To: Planholders for 2019
Autumn Ridge Subdivision HMA Removal and Paving Project
Along Autumn Ridge, Autumn Ridge South, Autumn Ridge North, Oakbrook Drive,
Summerwood Lane and Brookstone Drive West
Saginaw Twp (SCRC #190001)

ADDENDUM NUMBER ONE

Bidders are informed that the Plans, Specifications, and Contract Documents dated December 6, 2018 have been revised for the 2019 Autumn Ridge Subdivision HMA Removal and Paving Project along Autumn Ridge, Autumn Ridge South, Autumn Ridge North, Oakbrook Drive, Summerwood Lane and Brookstone Drive West in Saginaw Twp (SCRC #190001)

MANHOLE COVER ADJUSTMENT
NO SCALE

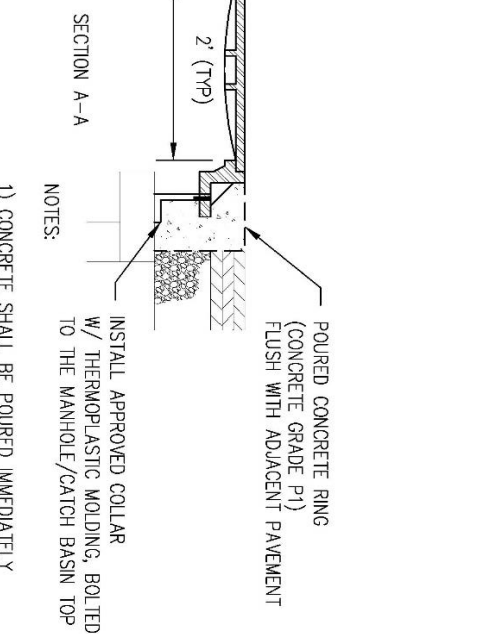
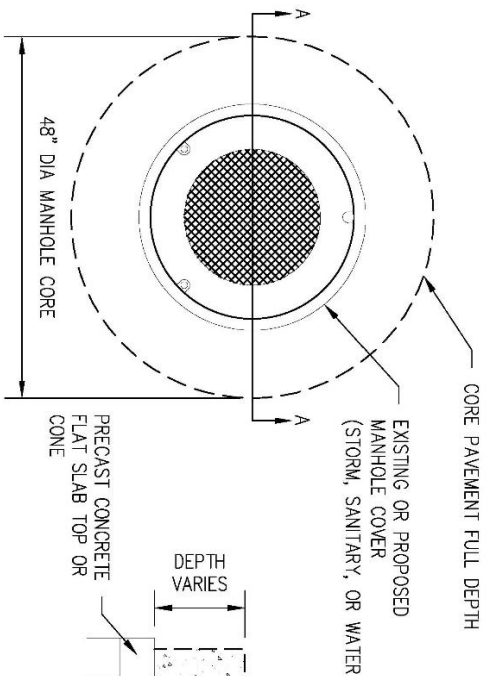
After the top course of HMA has been placed, the Contractor shall core the existing pavement full depth, centered on the manhole, remove loose material, remove temporary drainage structure plate, install thermoplastic molding collar, trim collar to heights and slope, reinstall casting, and pour concrete to match finished road surface.
